Daisy

Peripherals

Audio

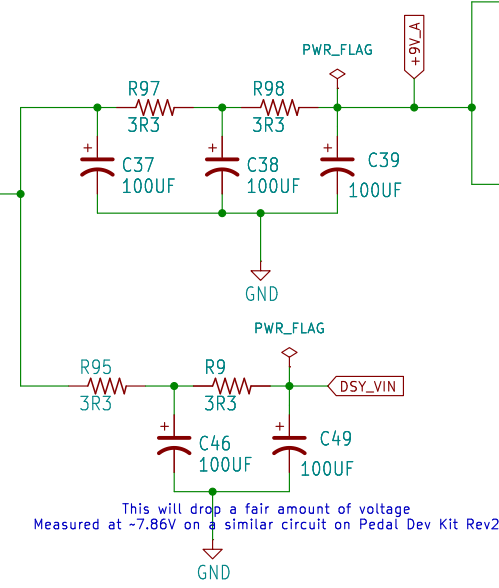
This will drop a fair amount of voltage  
Measured at -8.6V on similar circuit on Pedal Dev Kit Rev2

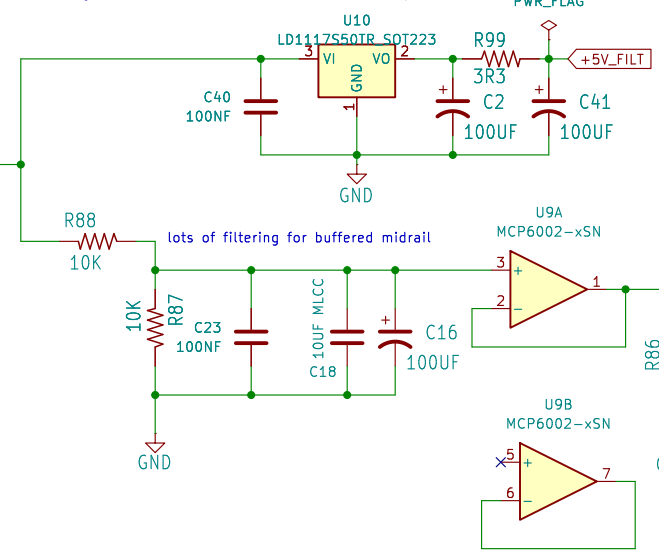
We can remove this, and simplify slightly if we:

- Power Headphone Amp from +3v3\_A
- Change DAC output op-amp to a rail-to-rail opamp that supports higher voltage (i.e. OPA1652)
- Power DAC output op-amp from +9V\_A
- Add LM4040 for +5V reference for CV inputs
- Use TL074 or something for AREF\_AUDIO\_BIAS buffer instead, and power at +9V

CV I/O

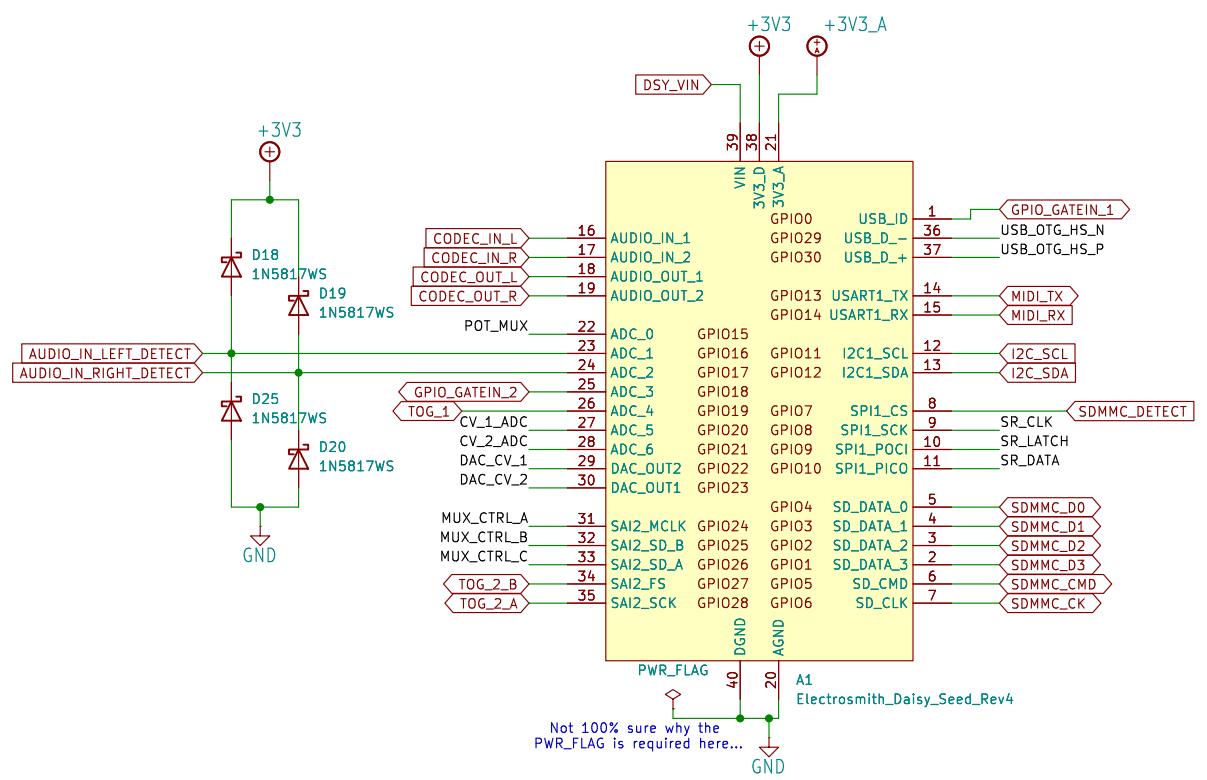
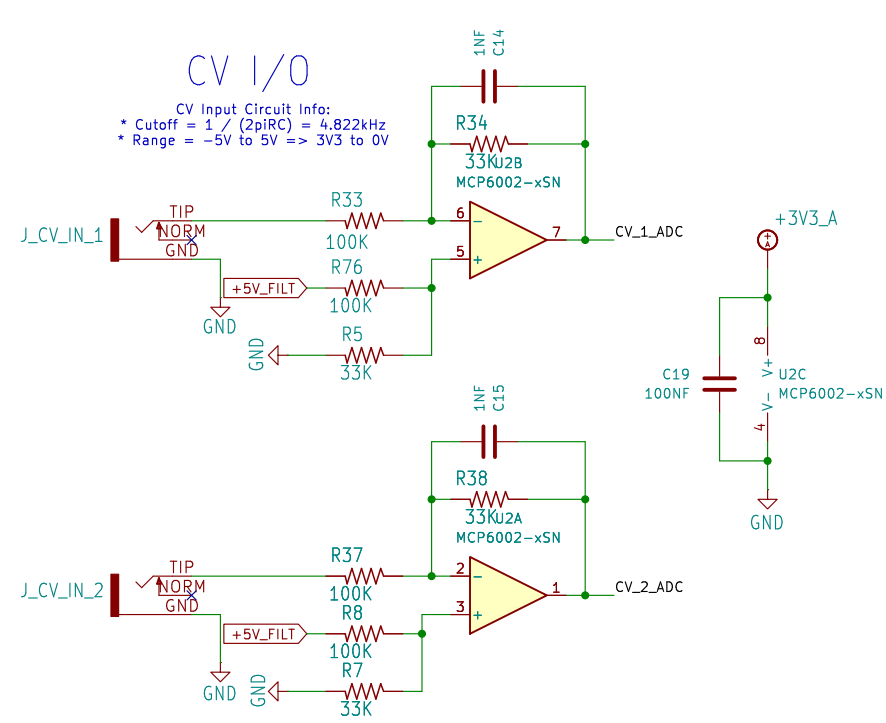
Not 100% sure why the  
PWR\_FLAG is required here...

# MIDI

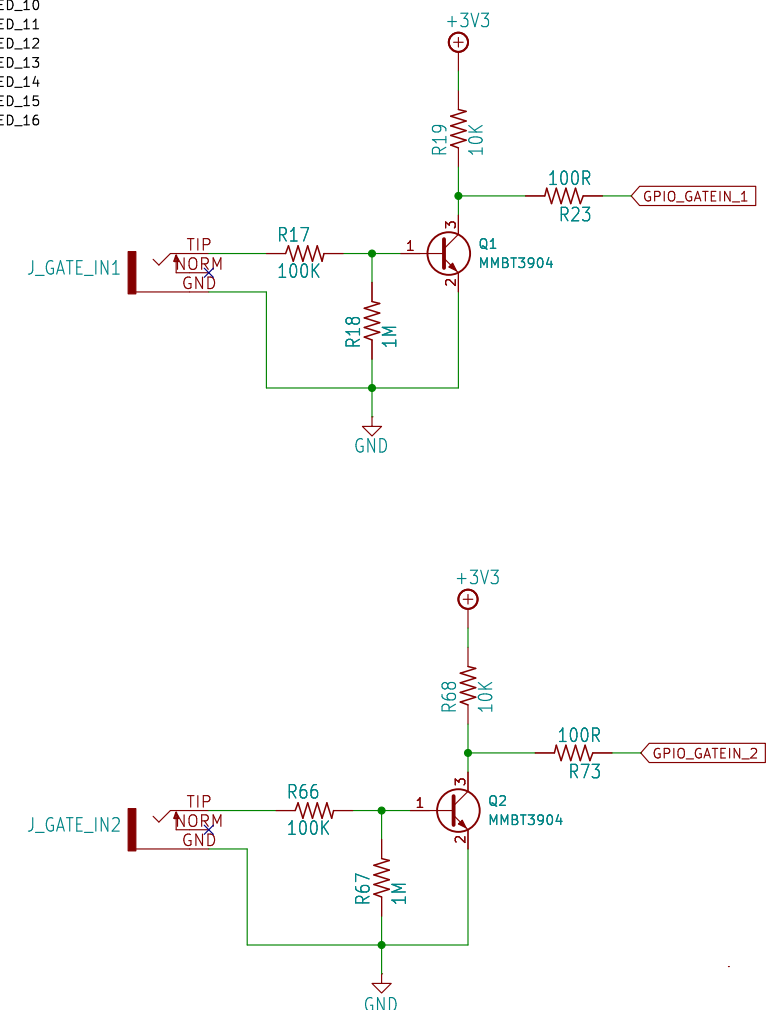
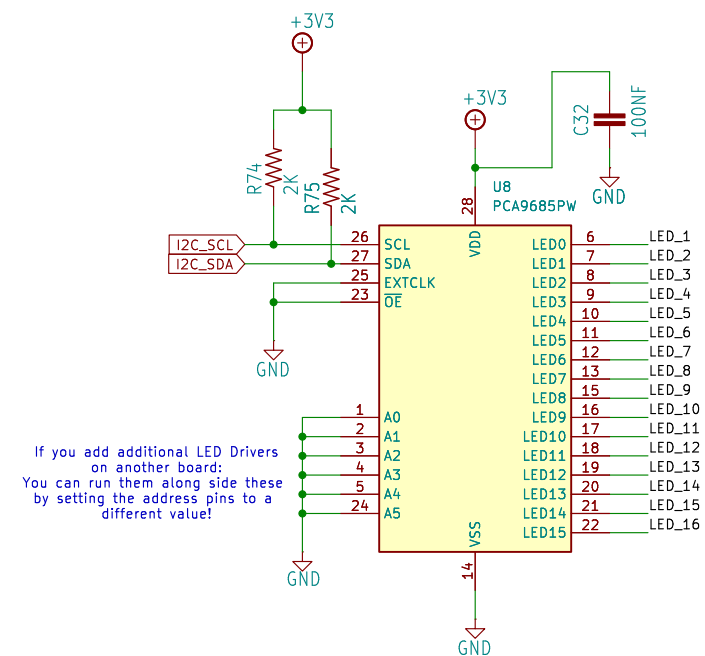
The PWR\_FLAG signal is noted as being awkward to implement here, but it is recommended for input isolation.

## AUDIO I/O

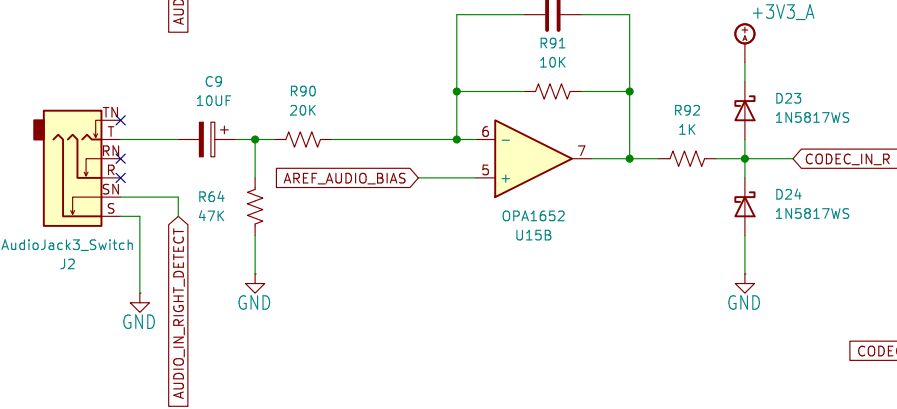
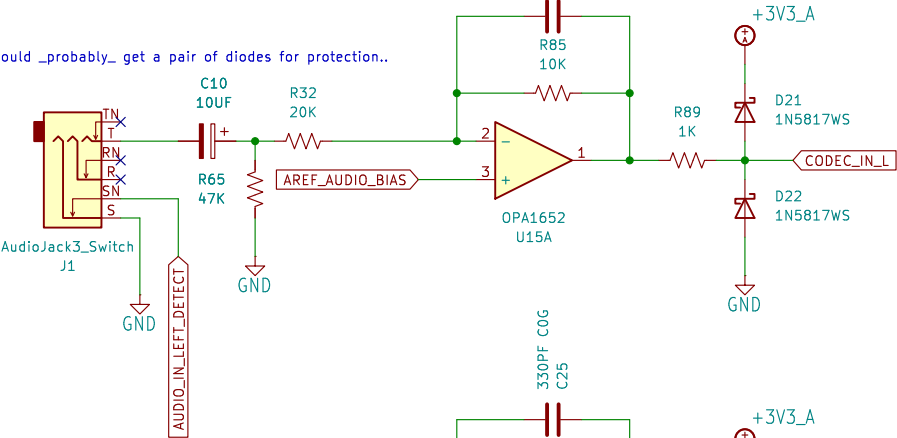
...s should \_probably\_ get a pair of diodes for protection..

Gain is set to target +4dBu (maximum)  
obviously this does not make it a pro-line-level device that way..  
we'd need to probably have a certain amount of headroom.  
If, instead we look at this as a -10dBV device, then we have  
-14dB of headroom with these values.

Alternatively we can go closer to the PCM3060's "2Vrms" reference and just do:  
 $G_{in}=0.5$ ,  $G_{out}=2$  :shrug:

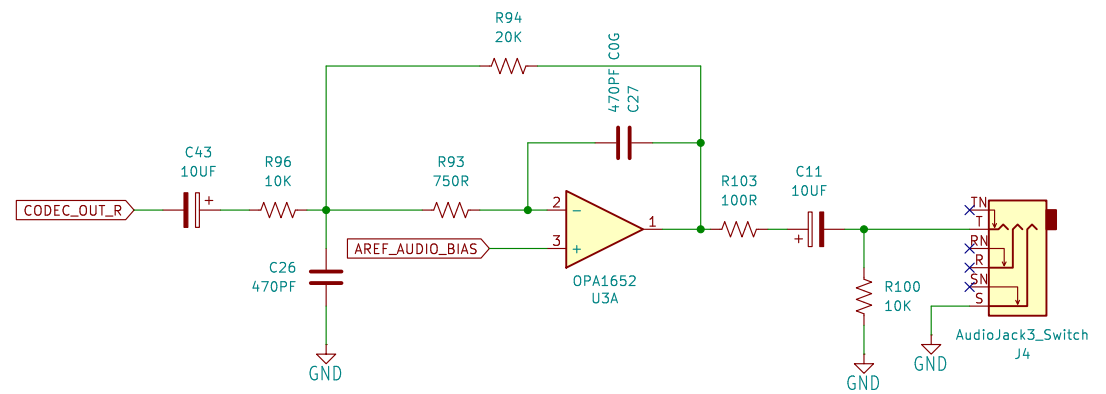
For now, I've implemented the left channel of audio with less atten/gain.

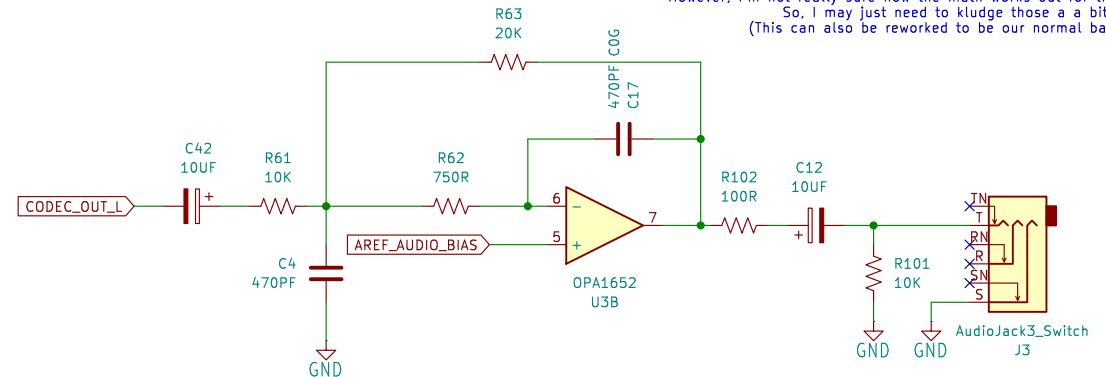
I updated these to be gain of 2.  
However, I'm not really sure how the math works out for the other two values..  
So, I may just need to kludge those a bit IRL.  
(This can also be reworked to be our normal basic filter)

DECISION - Two Choices:  
1. Add LD1117 (or LP2985) or other 5V Linear Reg.  
2. Power TPA6110 from Seed's 3v3A
